ZONING BOARD OF APPEALS MEETING
LOCATION: TOWNSHIP ANNEX, 7527 HIGHLAND ROAD, WHITE LAKE, MICHIGAN 48383
THURSDAY, APRIL 24, 2025 – 6:30 PM

AGENDA

TO: Zoning Board of Appeals
FROM: Andrew Littman, Staff Planner
DATE: April 14, 2025

PRELIMINARY/FINAL SITE PLANS FOR:
WHITE LAKE MOTORS
MICHIGAN AUTOMOTIVE GROUP
CHARTER TOWNSHIP OF WHITE LAKE, OAKLAND COUNTY, MICHIGAN

SHEET:
C-5

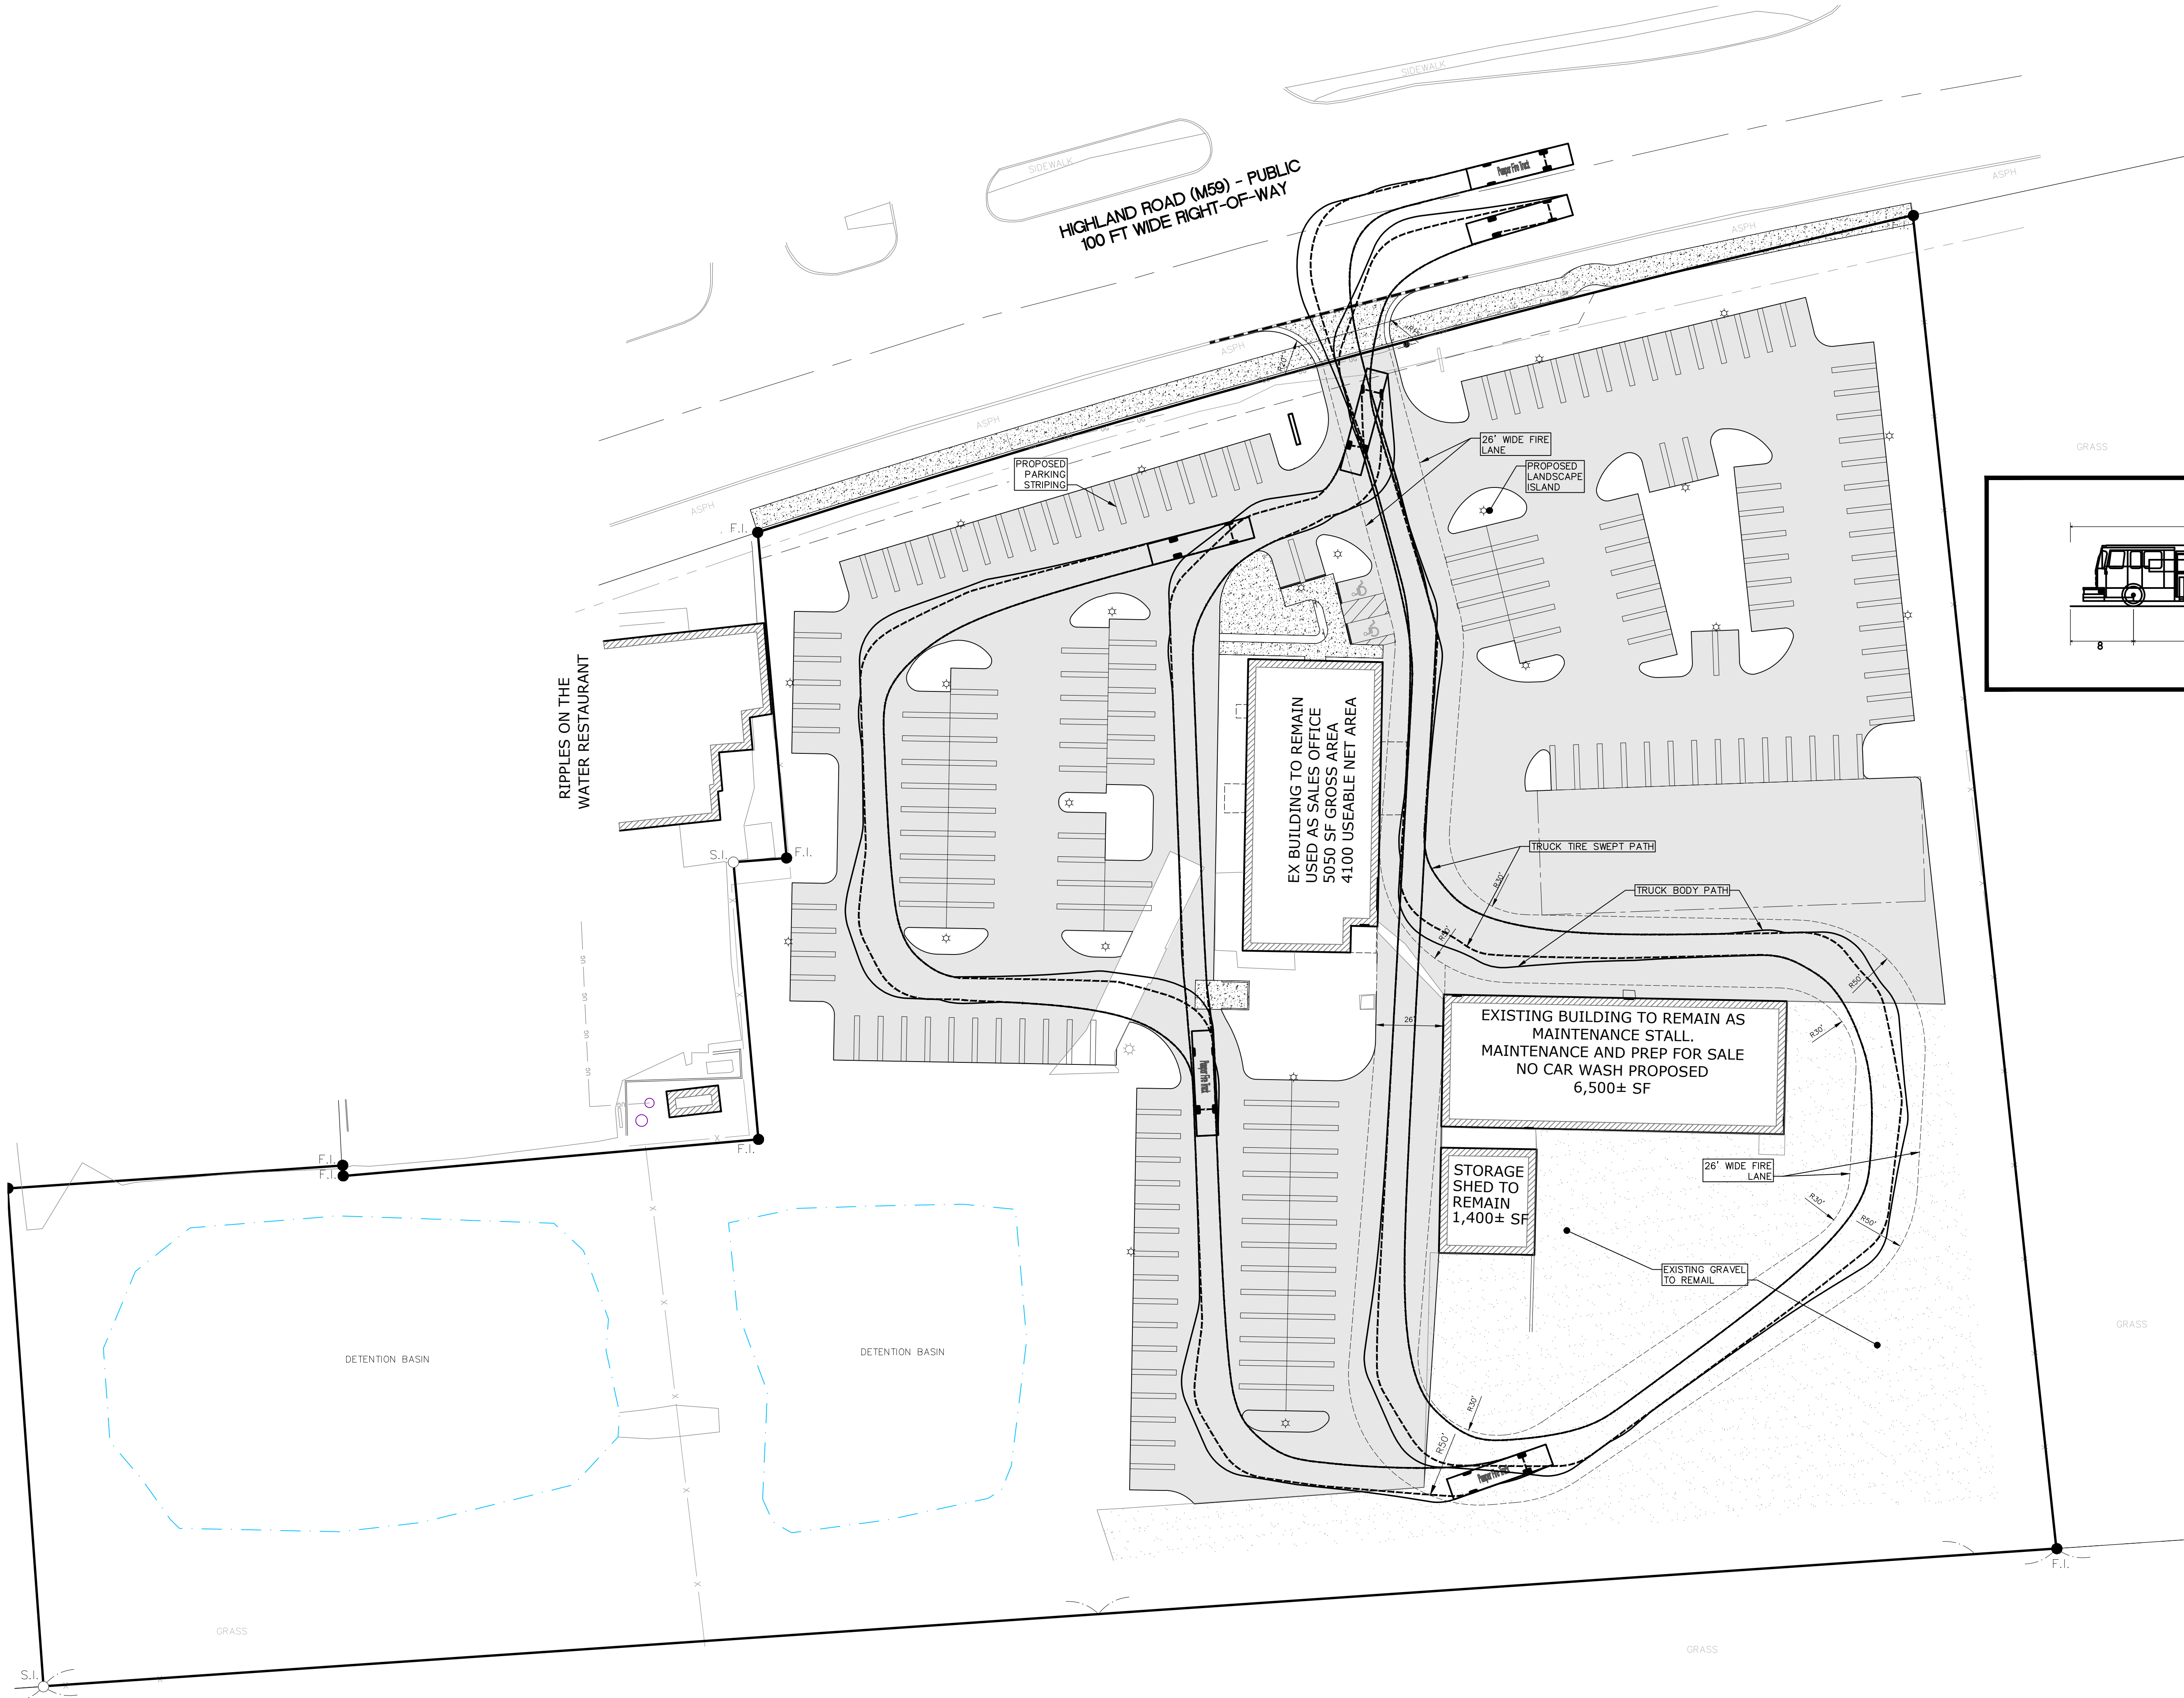
Topography:	Sheet C-2 and C-5 show existing site topography as well as the proposed grading. Much of the site is relatively level given the prior use.
Wetlands:	Sheet C-2 states "There are no apparent wetlands on site per national wetlands inventory mapper". A wetland survey is provided via the National Wetland Inventory service. Wetlands abut the site along the east, south, and west property lines.
Woodland:	The site is relatively clear of mature tree clusters per prior uses. Mature trees and vegetation are located near the existing detention basins in the site's southwest corner.
Soils:	Oshtemo-boyer loamy sands and Houghton and Adrian mucks are present on the site.
Water:	No natural bodies of water are onsite. Sheet C-2 states the site is located in Zone "X" (areas determined to be outside of 0.2% annual change floodplain) per FEMA map No. 26125CO337F, dated 09/29/2006.
General Notes:	None.

We note that concrete curbs are not shown on Sheets C-4 or C-5. However, concrete curbing shall be provided at the end of all parking areas and stalls. The applicant has stated they plan to seek a variance from the Zoning Board of Appeals for this requirement.

SHEET
C-6

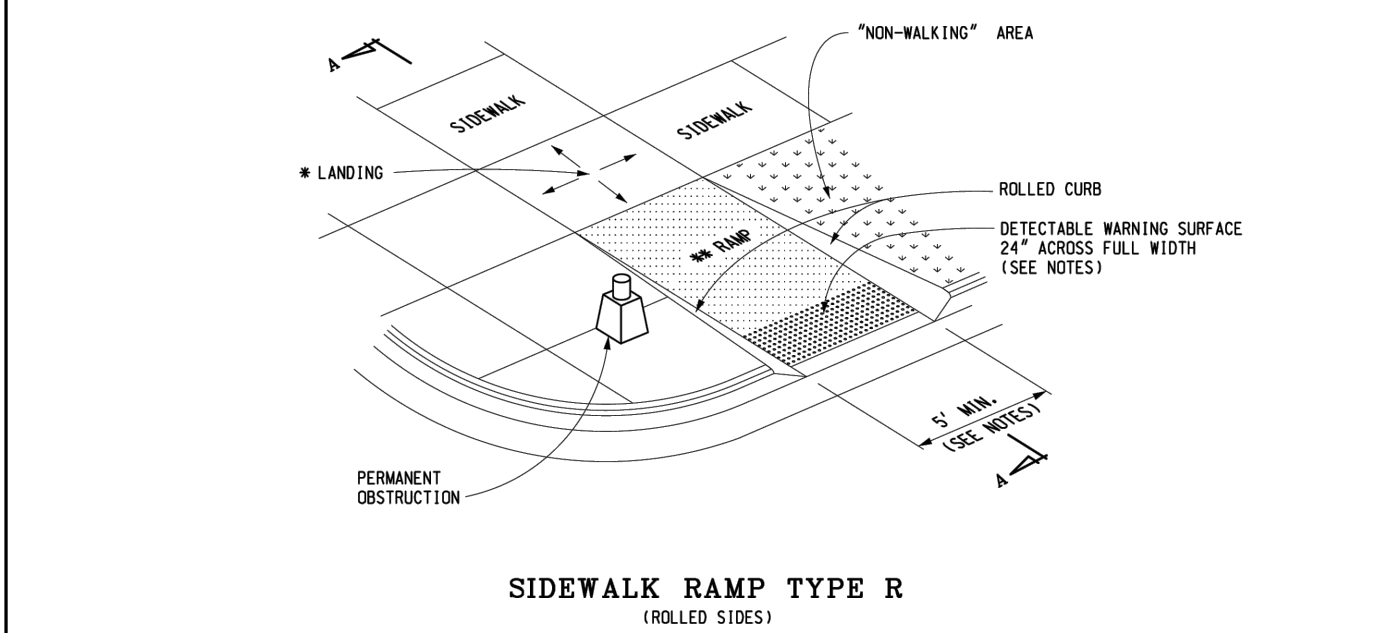
Emergency vehicle maneuverability is shown on Sheet C-6. We defer to public safety as to the feasibility of the proposed layout to accommodate emergency vehicle traffic.

Fire lane locations are shown on Sheet C-6. The buildings do not currently have FDC connections. We defer to Township Public Safety for any utility capacity or locations concerns.

L-1

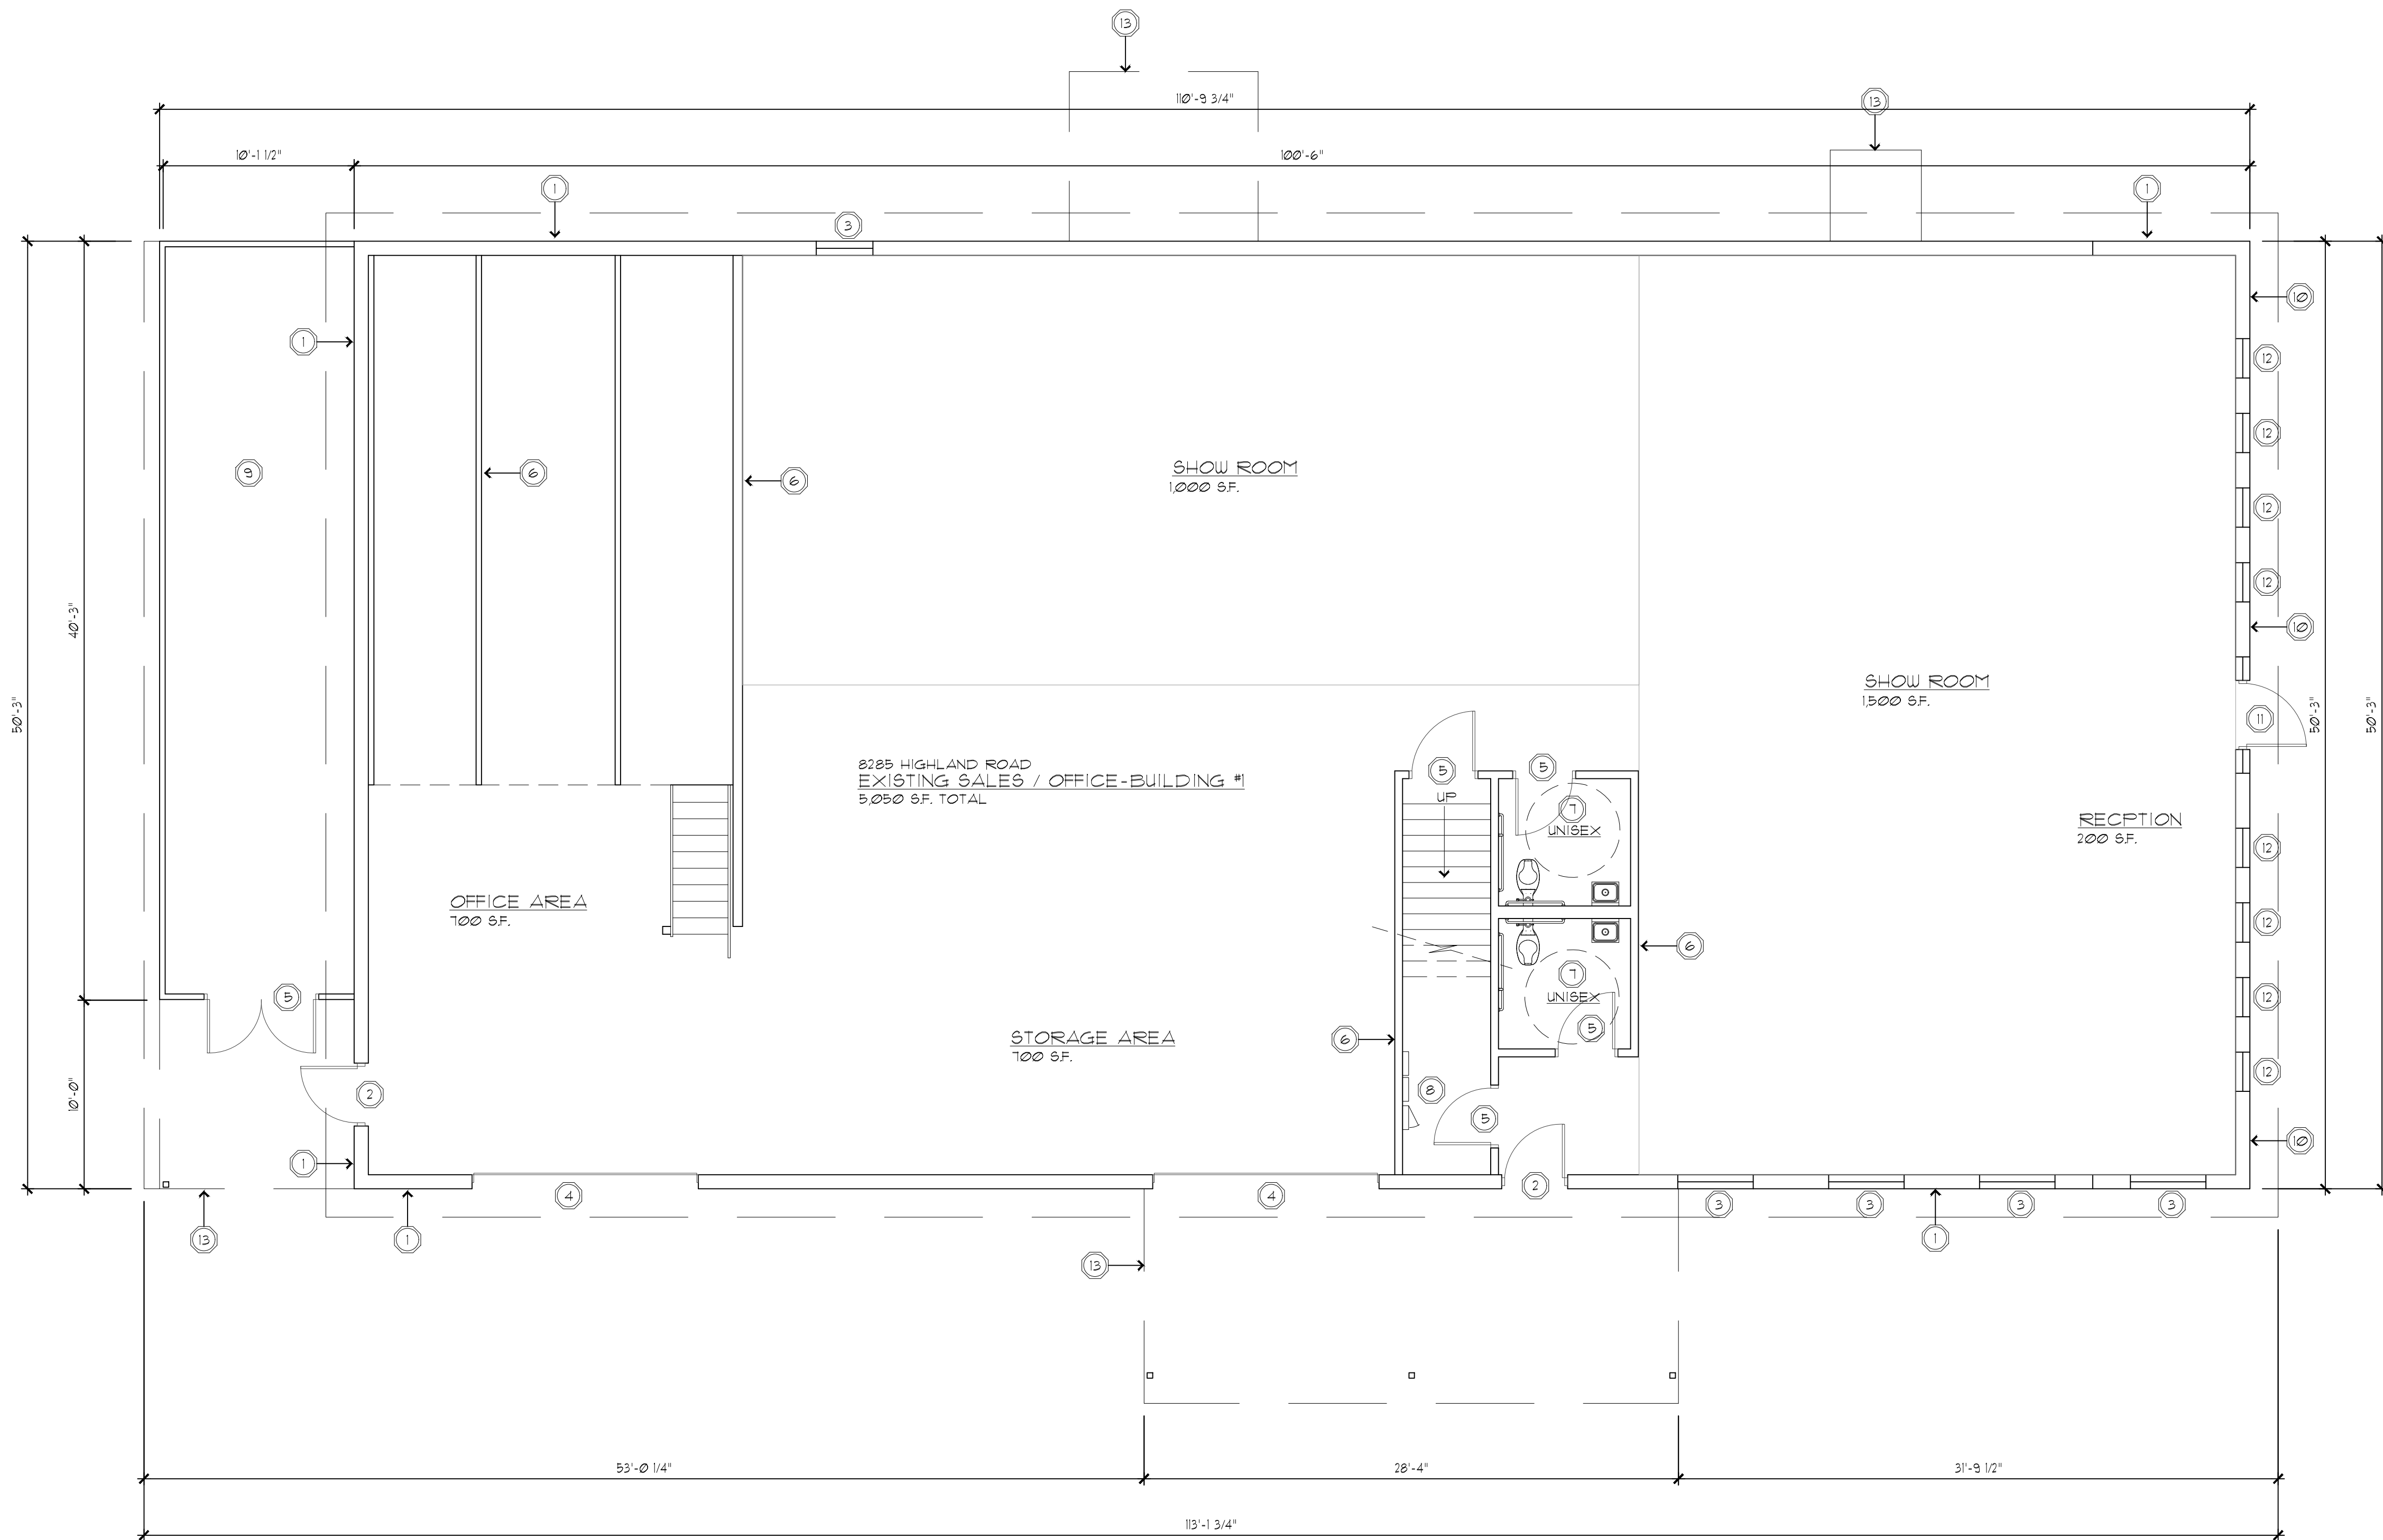
Sheet L-1 of the Applicant's plans show the interior landscaping calculations. Fifteen percent of the total lot area (273,120 square feet) equals 40,968 square feet. Therefore, 137 trees (40,968 / 300) and 683 shrubs ((40,968 / 300) x 5) are required. The Applicant's landscape plan shows 137 total trees but only 288 shrubs, which is deficient by 395 shrubs.

1. *Sheet L-1-North side of easternmost detention basin- The proposed tree types and location have changed since the previous submittal. The easternmost Concolor Fir is too close to the existing storm sewer and also appears to be shown over the location where the existing Stormceptor is. Please refer to the existing as built plans for General RV for the Stormceptor location and show this structure on the landscape plan as well as relocate this tree. **Comment partially addressed.** Although the tree has been relocated away from the existing storm sewer, the location of the existing Stormceptor has not been shown on this plan sheet. Please show on this sheet.*

A note on Sheet L-1 indicates the large tree requirement along the Highland Road (M-59) greenbelt cannot be met due to existing utilities east of the access drive. While large evergreen and shade trees are not to be placed over underground or beneath overhead utilities, the applicant has provided the required count using ornamental trees that will not interfere with utilities. This will require a waiver from the Planning Commission.

Sheet L-1 provides interior landscaping calculations. The shrub counts are short of requirements. One hundred fifty four (554) shrubs will be required to meet standards or a waiver will be required.
